# NR001 & NR002

- **Summary of QC findings**
- Visual inspection
- Optical inspection
- RF measurements
- CMM measurements

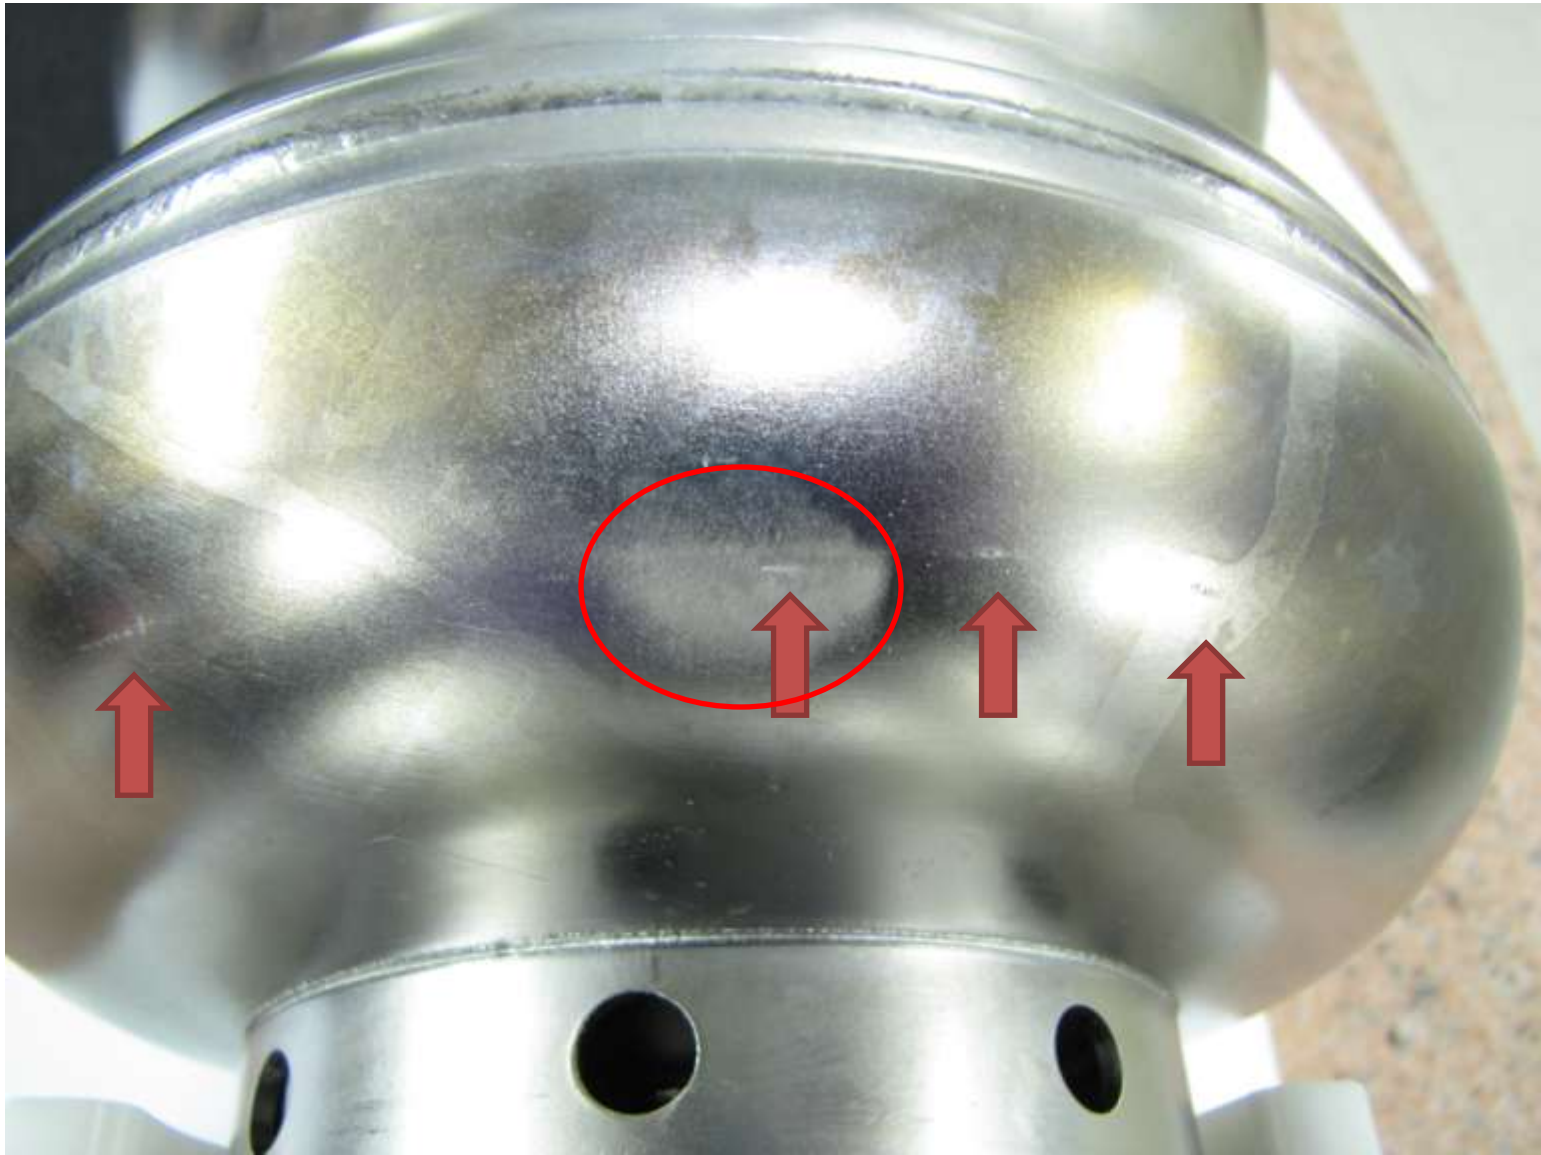
NR001 & NR002: all flanges have weld gaps and show a lot of polishing - **BAD**

NR001: dent on end cell - **BAD**

- Welding of all flanges shall be performed in order to avoid gaps. Perform tests to qualify each weld.
- Iris welds shall be inspected thoroughly and dumbbells qualified prior to performing equator welds.

- All handling and fixturing operations should be analyzed and improved to avoid any damage to the parts.
- The forming of the half-cells should be analyzed to identify the nature of the atypical horizontal streaks seen near the equator welds

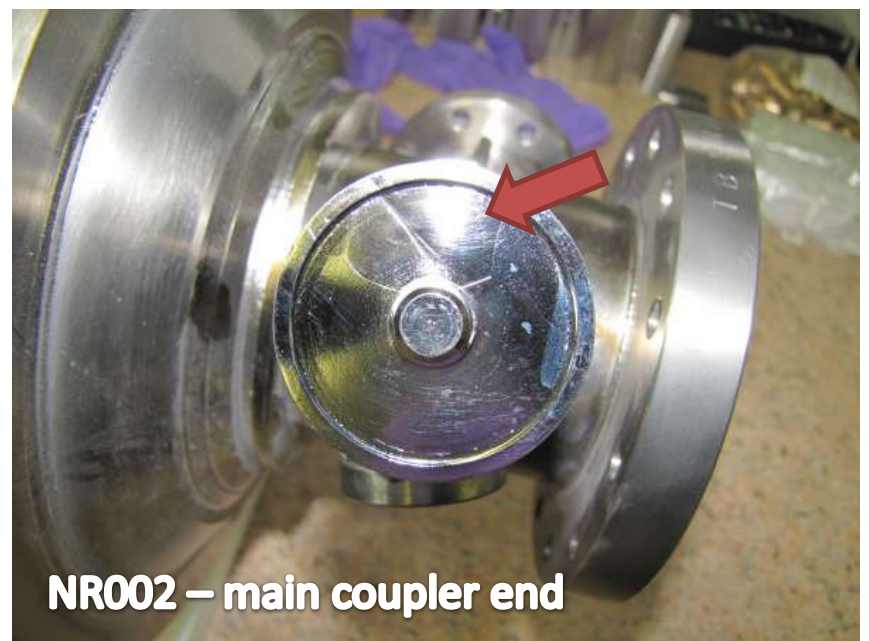
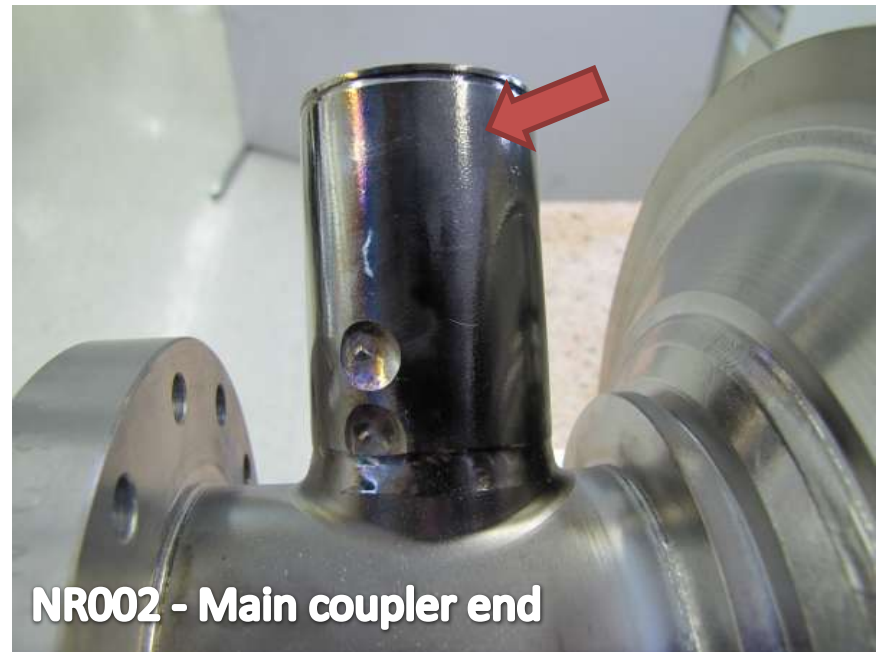
NR002: Discoloration, dirt (?) and fingerprint(?) inside beam tube at probe end - **BAD**.

NR001: scratches and buffed area on half cell. Fixturing? – not necessarily bad per se but a sign that fixtures/handling is not appropriate.

Iris welds

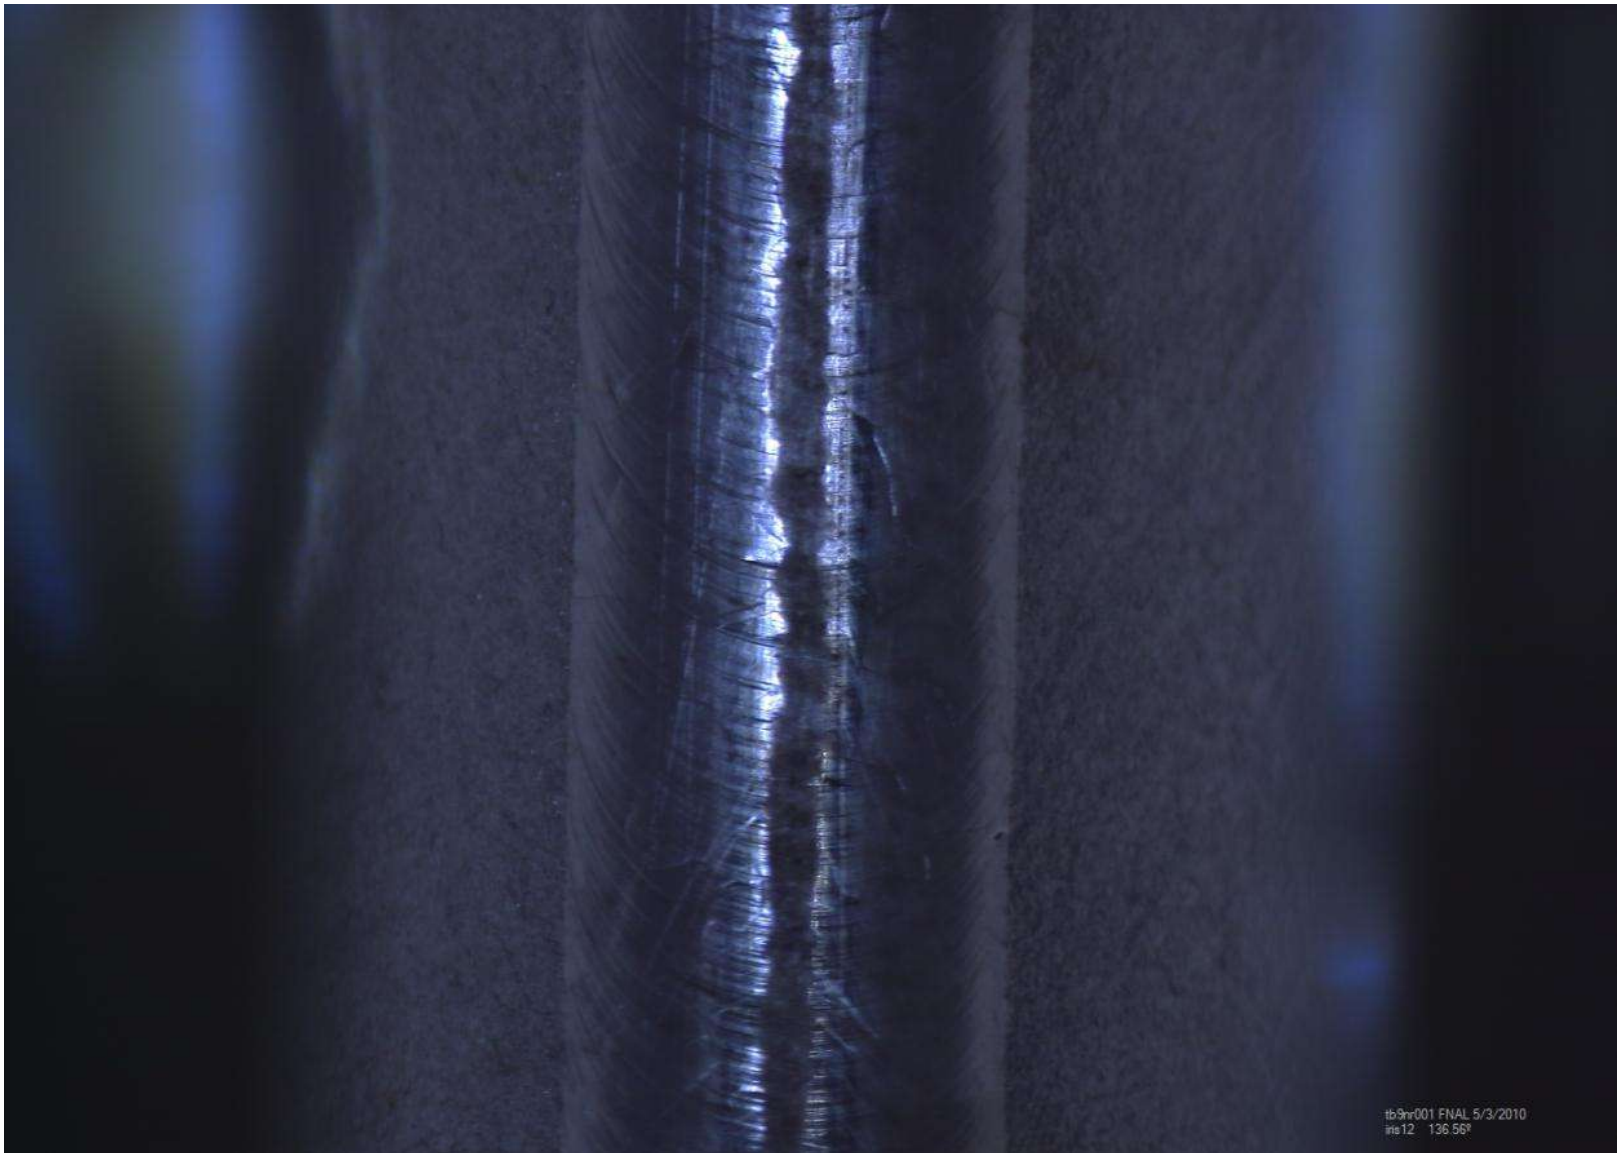
NR001 & NR002: this is a typical iris weld for these two cavities, just for reference.

NR002: unique defect on Iris between cells 2 and 3 – **BAD, this should be caught at the dumb-bell stage and the part discarded.**

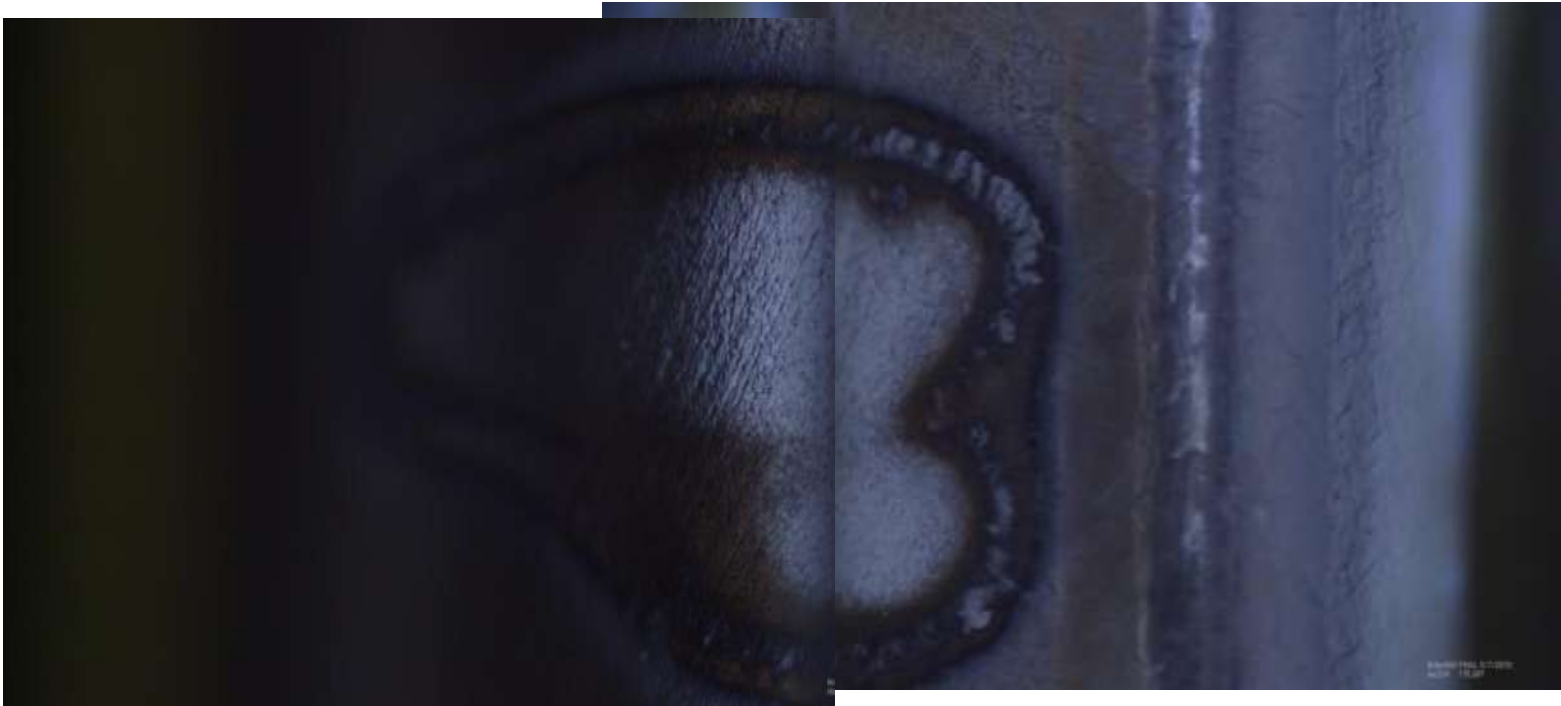
Large spot on iris weld between cells 2 and 3 of NR002.

**BAD – these defects should not be present**

NR002: Few of these spots are present near the welds, looks flat and may be an indicator of contaminations, perhaps bad vacuum during welding. **BAD, these defects should not be present.**

NR001 – iris5/6: reddish/brownish discoloration, perhaps benign but never seen before.

- The cleanliness of all parts and sub-assemblies shall be improved by large in all stages of fabrication.
- The vacuum level in the EBW chamber should be monitored (possibly improved?).

Equator welds

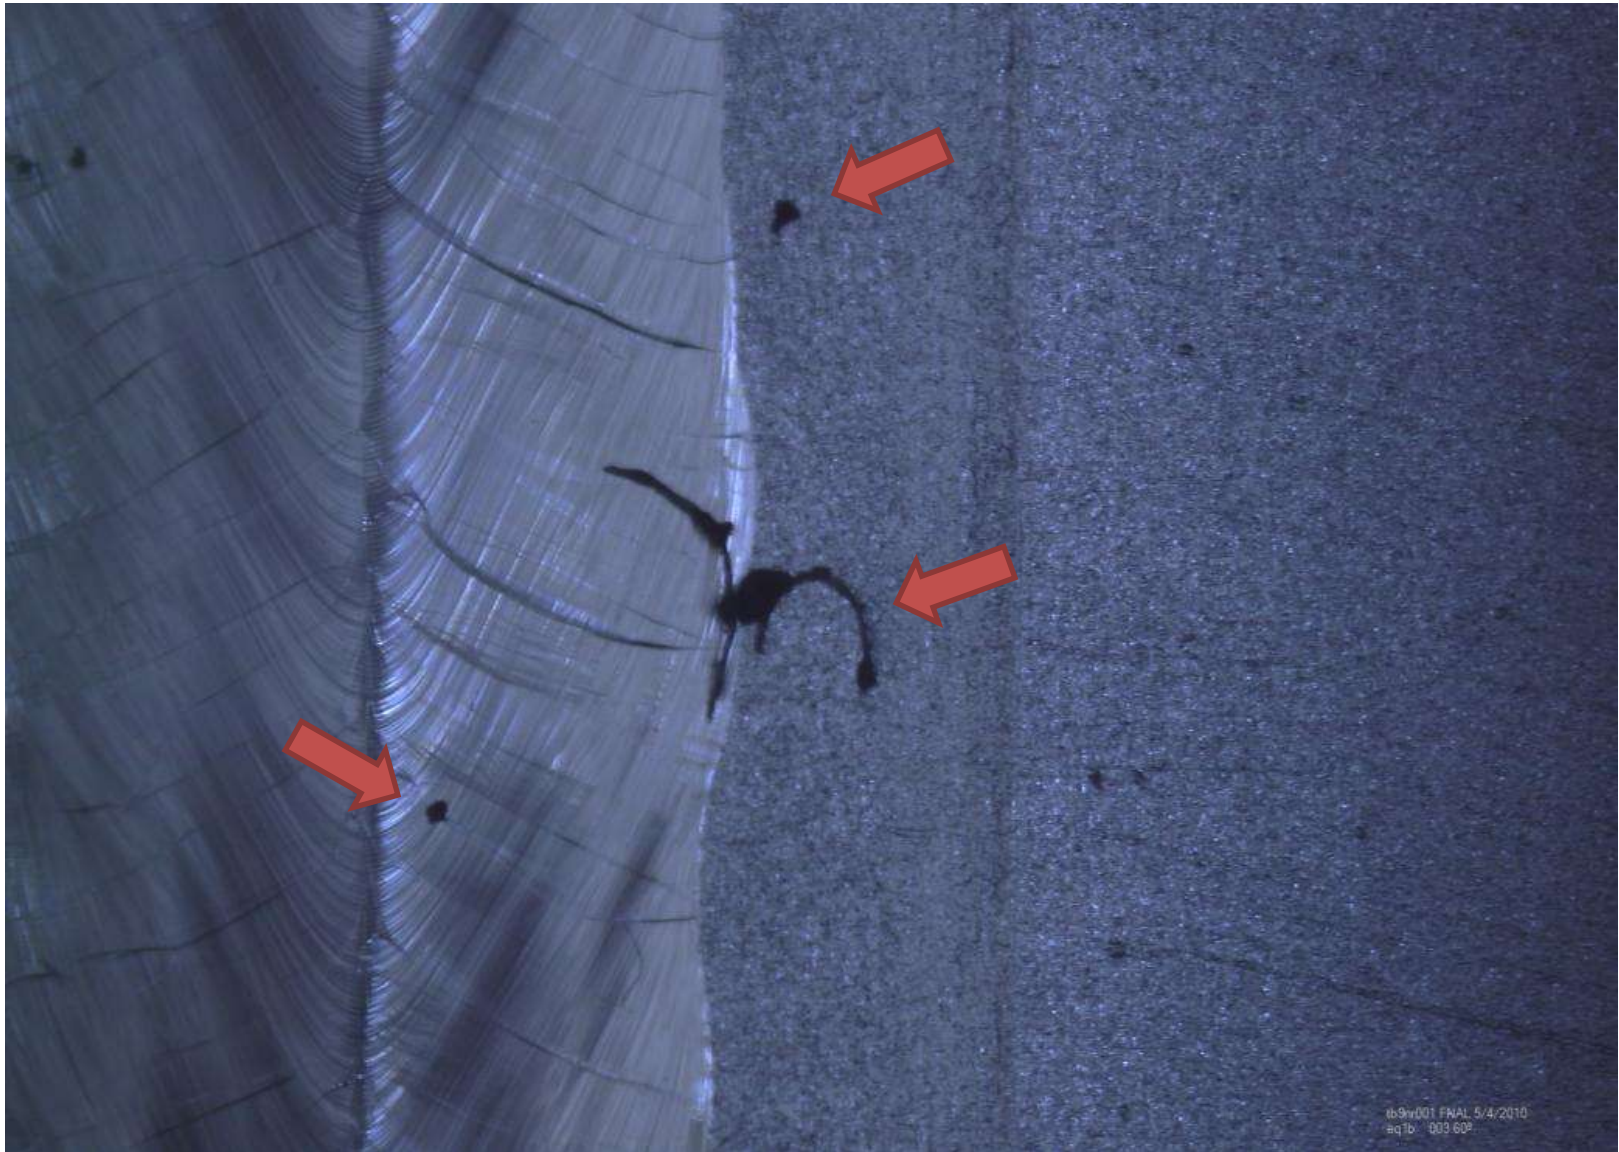
NR001: typical equator weld with non-typical horizontal lines. Not necessarily bad, could be related to the forming process and should be given some thought.

NR001 & NR002: typical dirt and fibers – **BAD**. Dirt should never be present before, during or after welding.

NR002: discolorations on equator weld, pictured is one of the worst extending ~20 deg and on both sides of weld. **BAD – these discolorations should not be present**

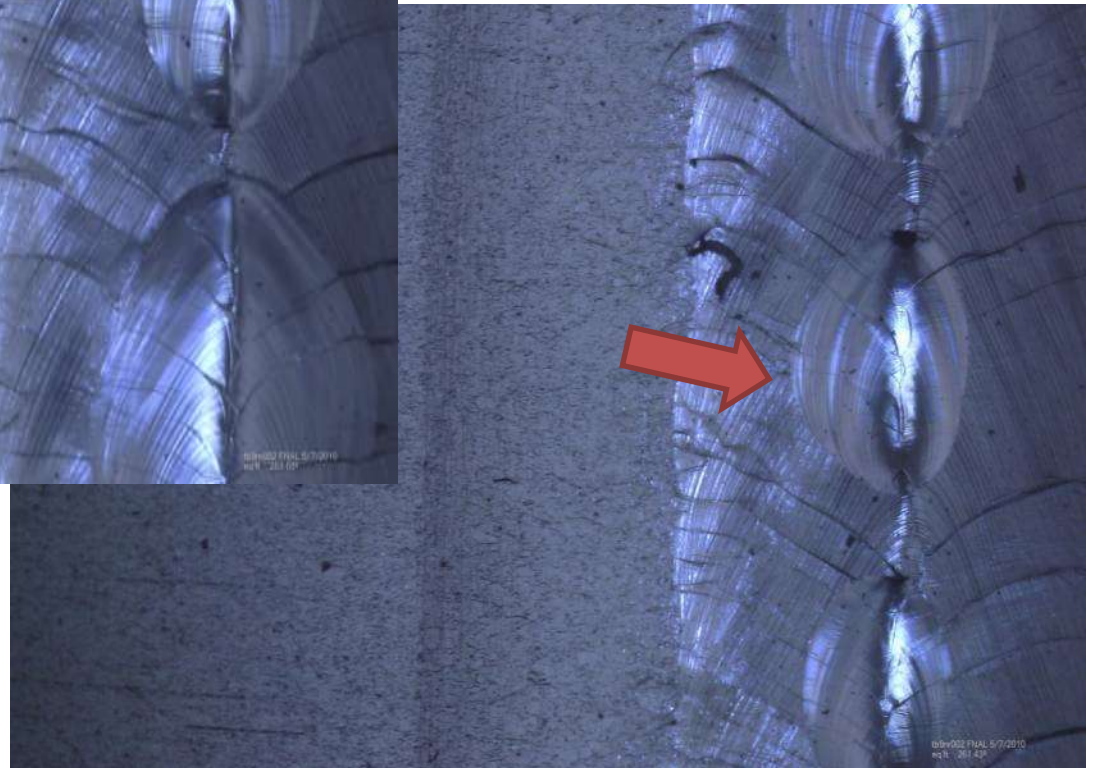
NR001 & NR002: Equator welds on cells 1 and 9 look different from the rest. Welds performed in a different orientation? Bumps are several hundreds of  $\mu\text{m}$  high. **BAD – these features should not be present.**

NR001 & 002: perhaps overlapping bead on equator weld, seen on all equator welds of both cavities. It's a bump and could cause quench. **BAD - Overlapping is less pronounced on cavities from other vendors.**

- The effects of the overlapping on equator welds must be studied and mitigated.
- The diameters of all equators appear larger than nominal, this should be studied.

## NR001

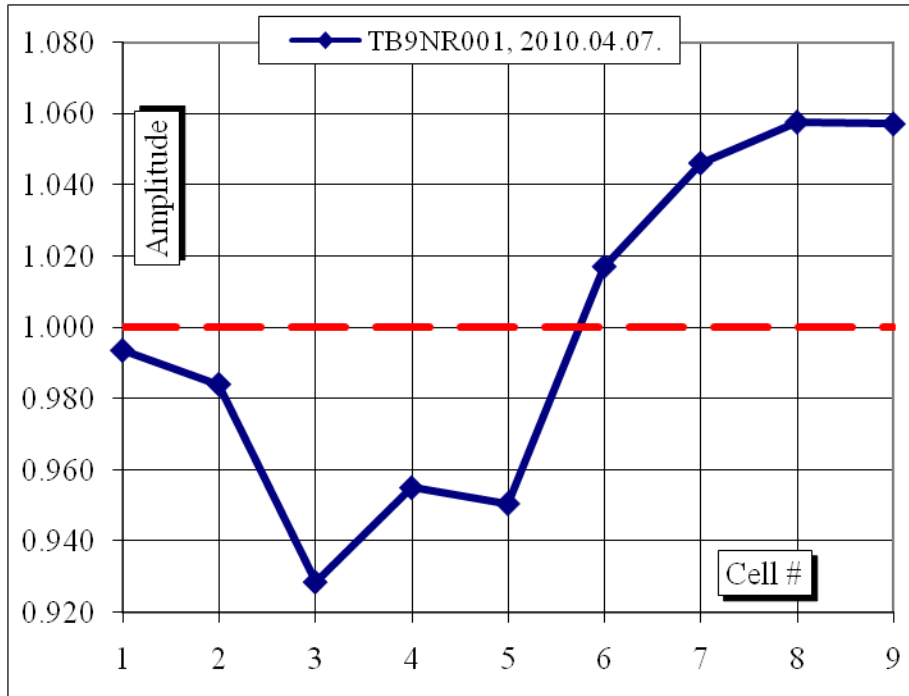
Field flatness  $E_{min}/E_{max}=88\%$

Better than typical untuned RI cavities

Worse than typical tuned AES cavities

NB: we will tune the cavities after 800C heat treatment

## NR002

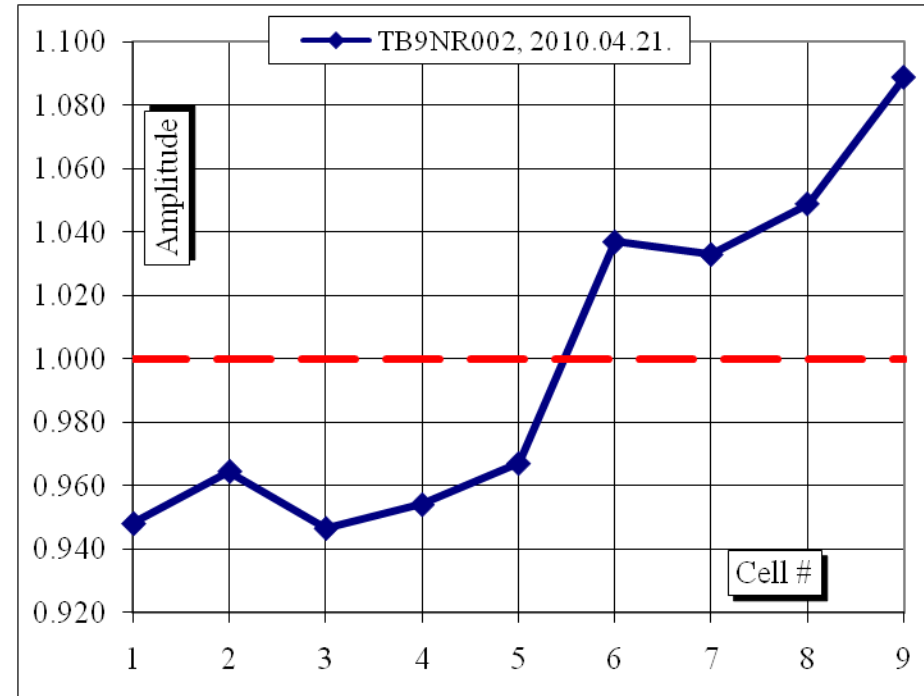
Field flatness  $E_{min}/E_{max}=87\%$

Better than typical untuned RI cavities

Worse than typical tuned AES cavities

NB: we will tune the cavities after 800C heat treatment
